Product Equality Declaration

We, Mobile Devices Ingénierie, declare on our sole responsibility for that the model C4MAX is exactly the same as the original certified product with FCC ID A6GC4MAX-3GNA, except for the difference specified below:

Old version	New version
Model Name	C4Max-3GNA-E	C4MAX
Marketing Name	C4Max-3GNA-E V2	C4Max-E V2
HW version	SAP00256	SAP00383
SW version	V1944	V1944
FCC ID	A6GC4MAX-3GNA	A6GC4MAX-E

Original

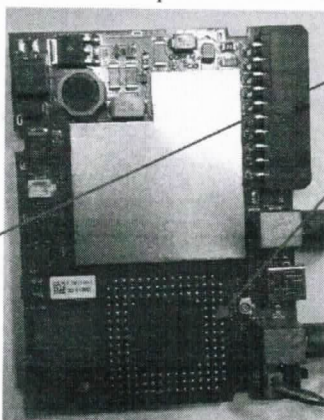
The only difference is there's no module on new product that we are going to sell

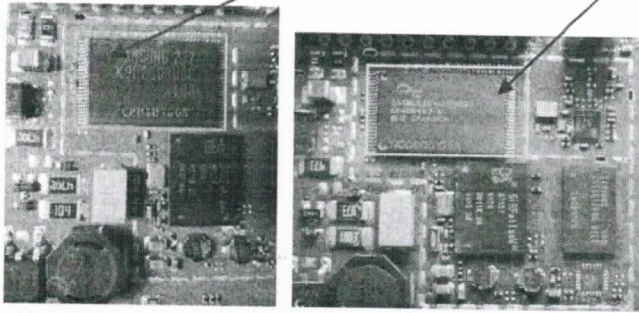
- We remove module, so there's no WCDMA, no GSM function

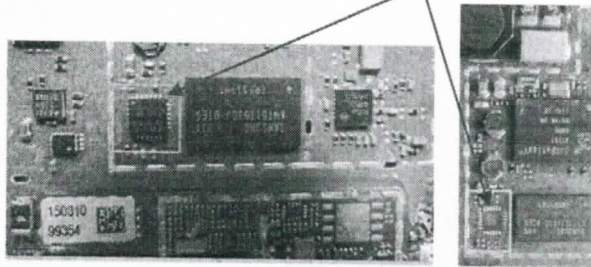
- We changed flash from Samsung brand name to Spansion, because the old flash is end of life
